STOCKTON UNIFIED SCHOOL DISTRICT

Expanded Learning Opportunities Program (ELOP) - Relocatable Classroom Buildings

The following additions, deletions and revisions to the plans, specifications and Addenda shall become a part of the plans and specifications. It is the responsibility of the General Contractor to submit the information contained in this addendum to all subcontractors and suppliers. The Bidder shall acknowledge receipt of the Addendum in the Bid Proposal. (Addendum number of pages: **32** pages + **77** attachments = **109** total pages).

DRAWING
 AD1-HAZ
 -A112

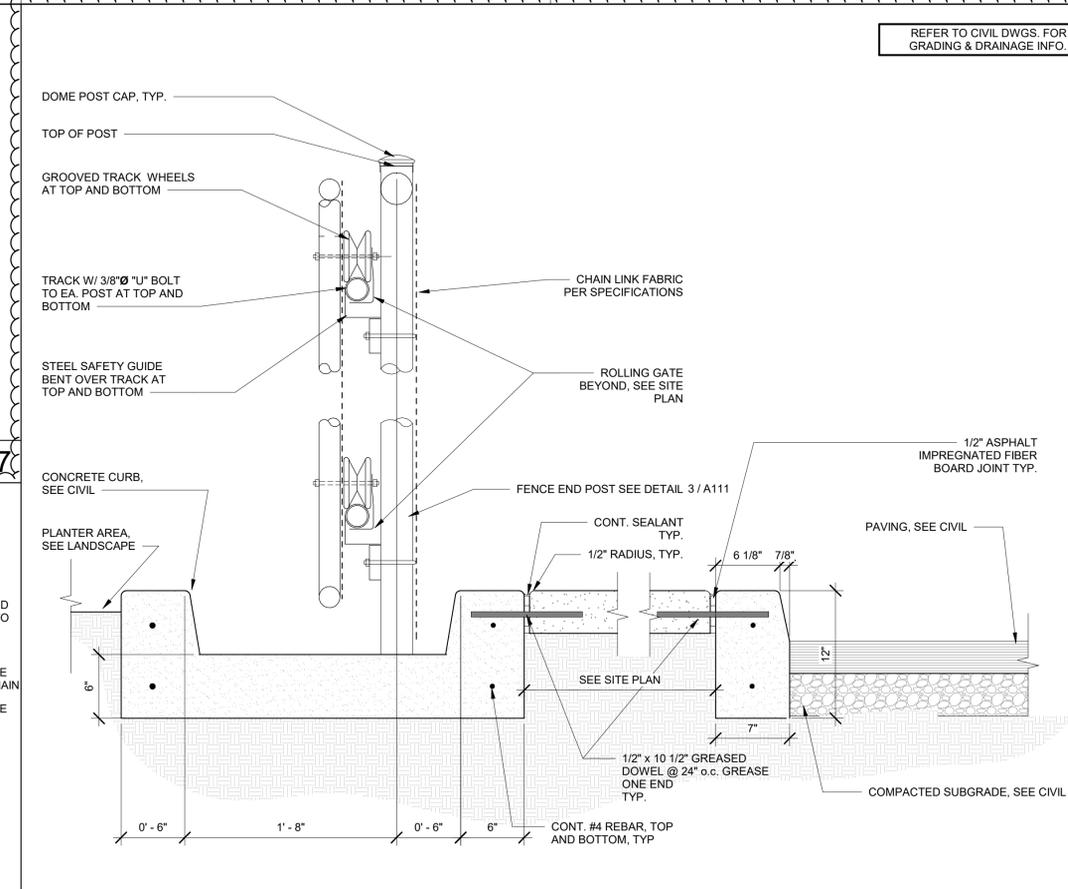
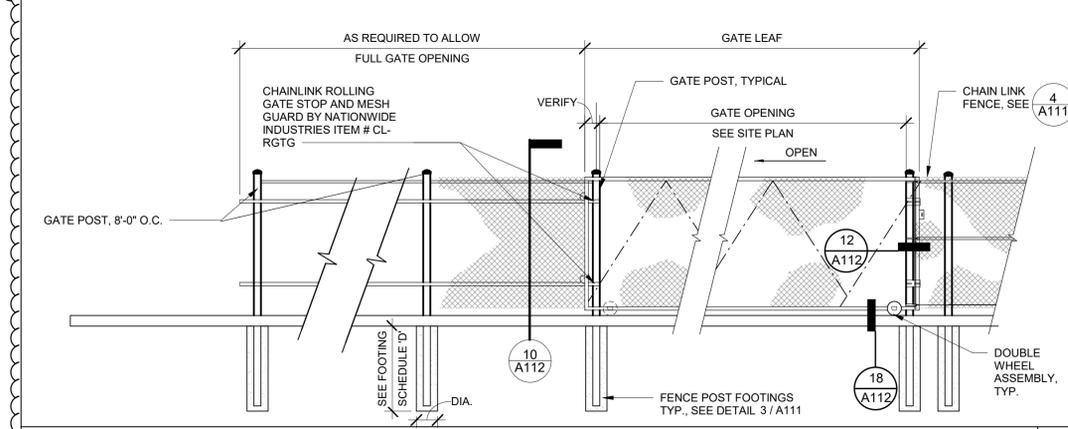
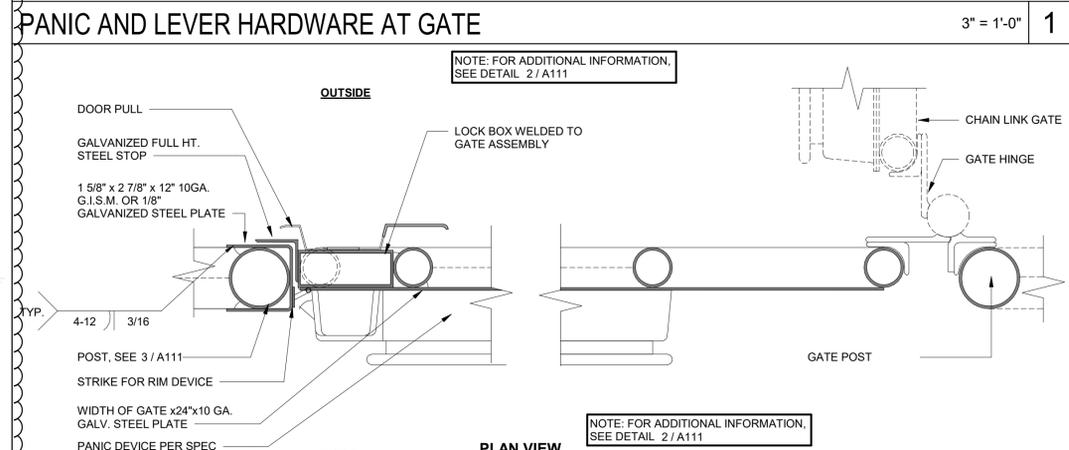
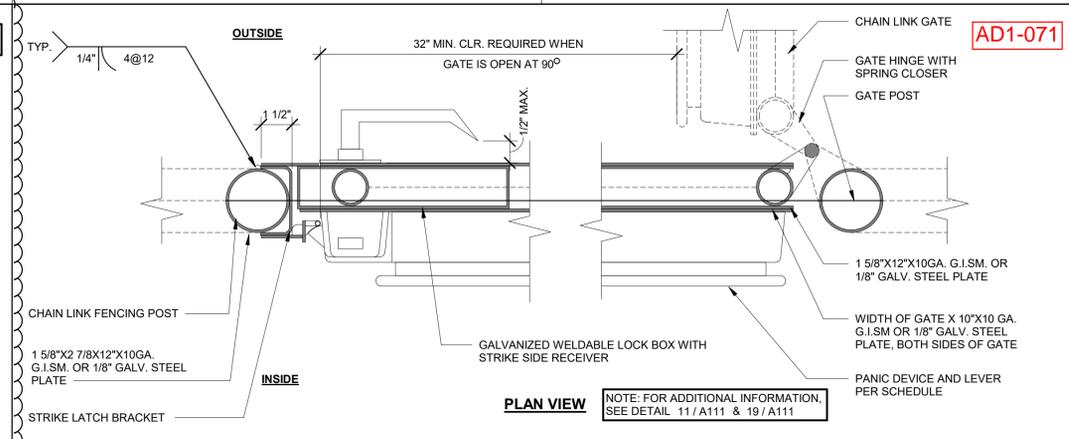
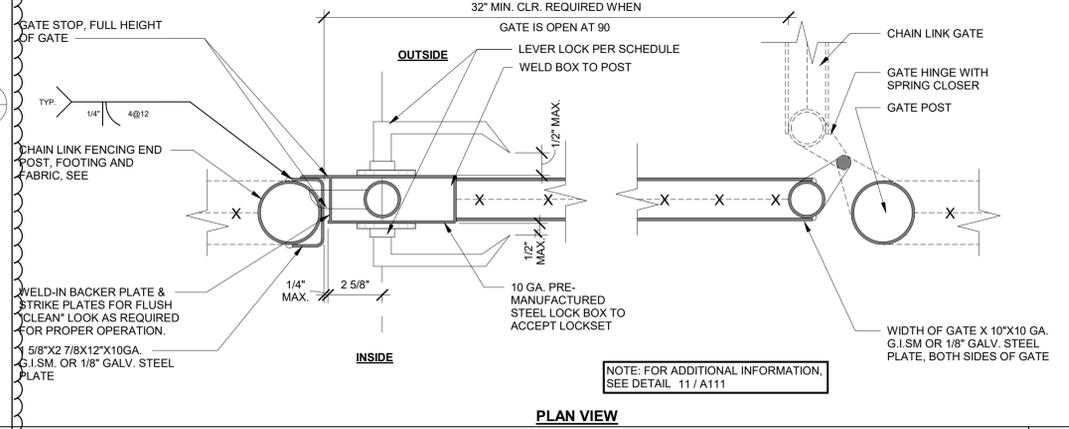
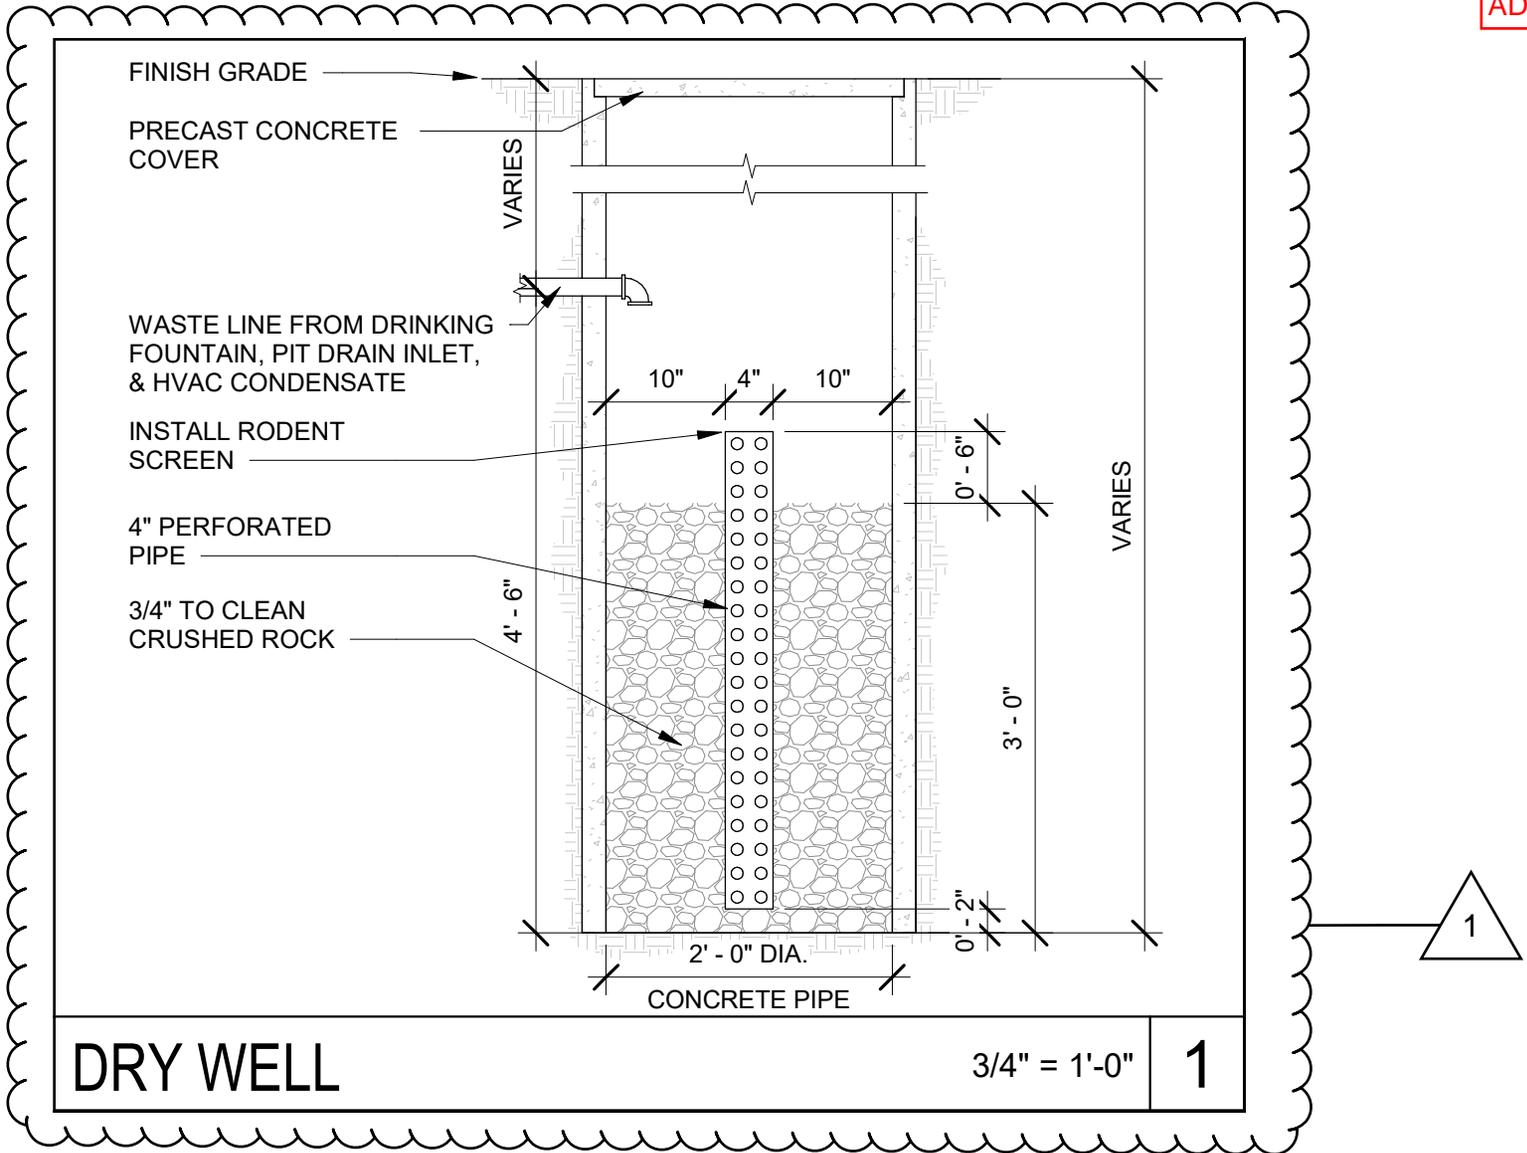
1 - 071: DRAWINGS, SHEET A112 – “SITE DETAILS”, revise as follows:A. Per attached drawing **AD1-HAZ-A112.**

1. Details 10, 11, and 12 have been revised.
2. Detail 16 has been crossed out.
3. Detail 18 has been added.

JOB NUMBER:
23-12908.00
DWG. DATE:
02/20/25
AD1-HAZ-
A201

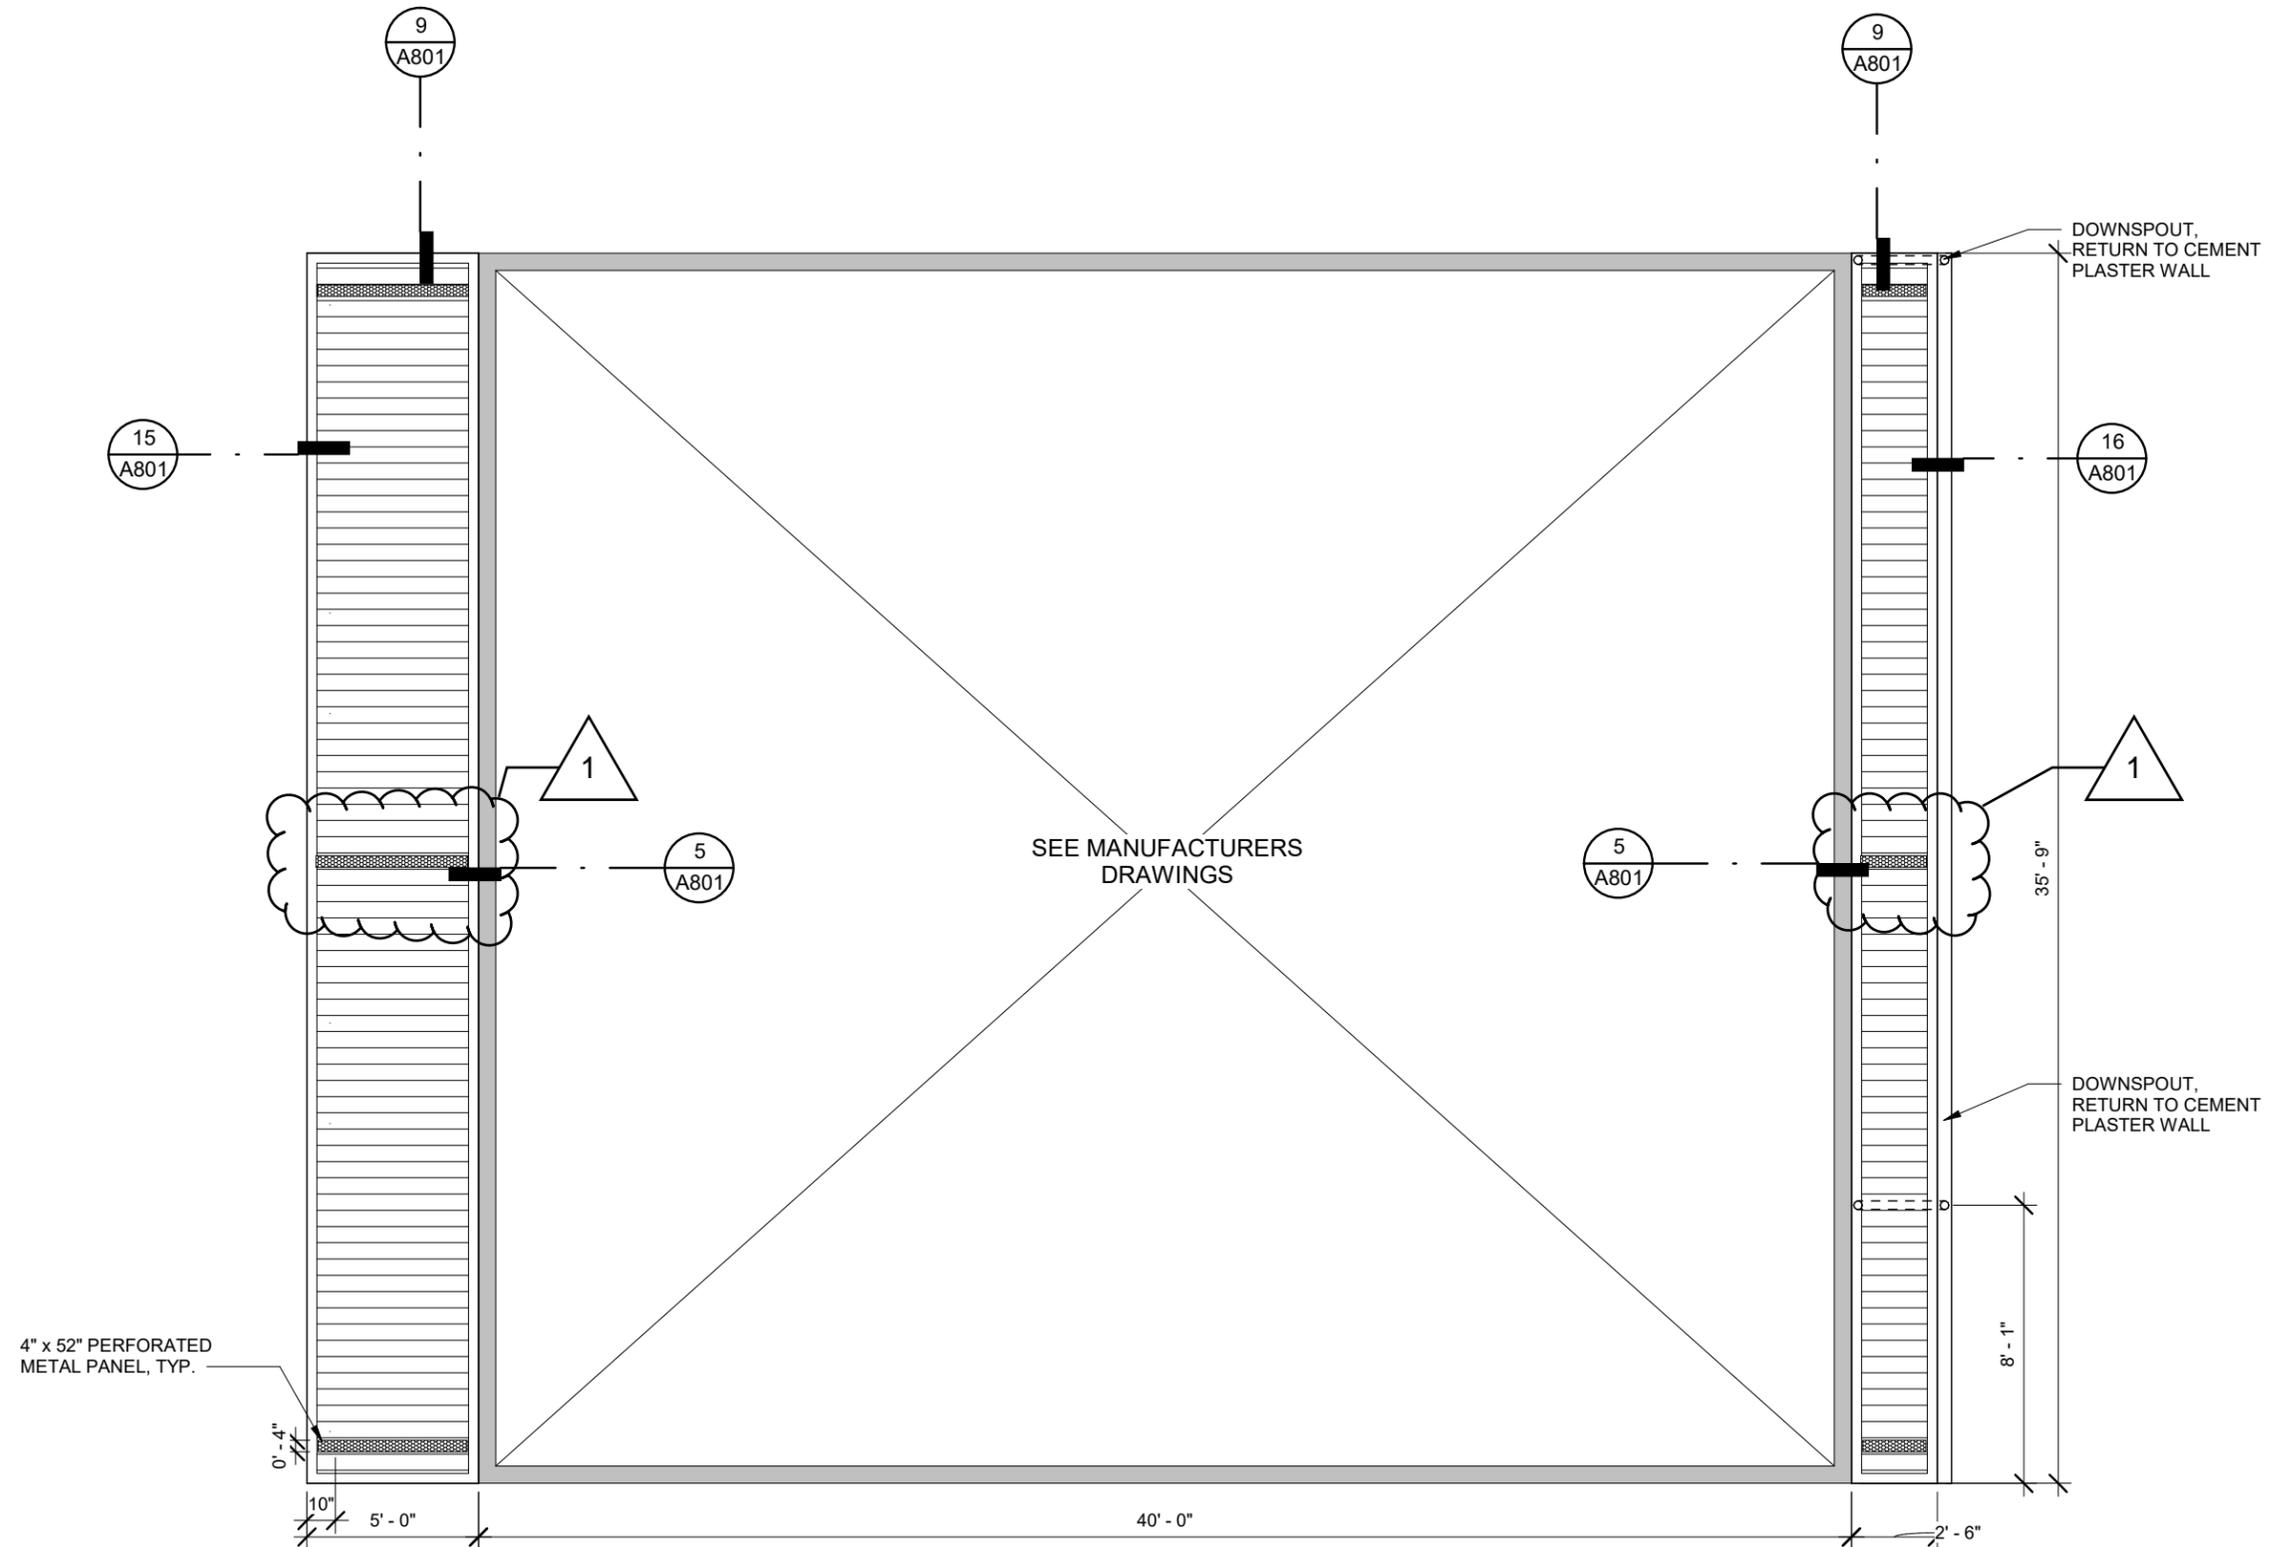
1 - 072: DRAWINGS, SHEET A201 – “PLUMBING FLOOR PLAN”, revise as follows:A. Per attached drawing **AD1-HAZ-A201.**

1. Detail 1 has been revised.
